Proposal for a new draft Regulation on frontal collision of buses

(This proposal is based on document ECE/TRANS/WP.29/GRSG/2007/33)

Figure 1. Test device of the residual space.

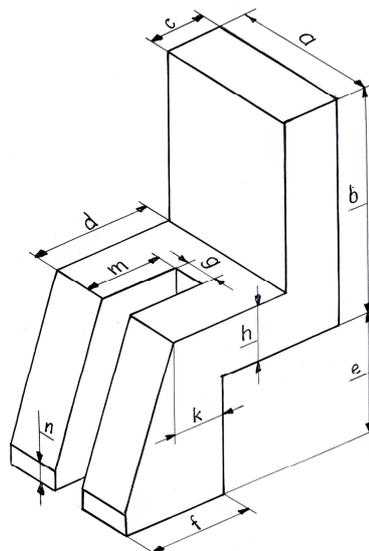
5.3.1. Amend to read (the red wording is new and some wording has been deleted).

After undergoing the test referred to in paragraph 5.2., the front bodywork shall exhibit a residual space **specified by the test device shown on Figure 1**. The **driver (or crew)** seat shall be in its [median] position for the assessment of the **residual** space.

That means: no structural parts, components of the driver (crew) compartment shall contact or intrude the residual space during and after the test.

Explanation: The driver (crew) may sit on the seat in different positions, so the required unharmed residual space must be bigger than the contour of a manikin. This is a strong safety issue. The test device shall be simple, cheap, and able to detect the easily the structural intrusions.

Figure 1. Positions of the impact plate

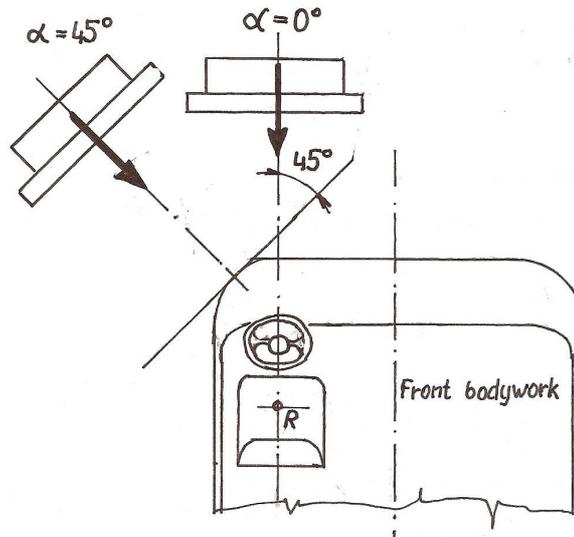
- 3.2.1. if the impact direction $\alpha = 0^\circ$, the vertical central plane of the impact plate shall go through the R point of the driver (crew) seat

3.2.2. if the impact direction is $\alpha = 45^\circ$, the impact plate shall strike the test piece tangentially on its corner. (See Figure 1.)

3.2.3. The central point of the impacting plate shall be in the height of the R point of the driver (crew) seat.

Argument: statistical data and many in depth accident analysis proved, that these two kinds of accidents have the same frequency and are the more dangerous front impact situations in relation to the driver's safety.
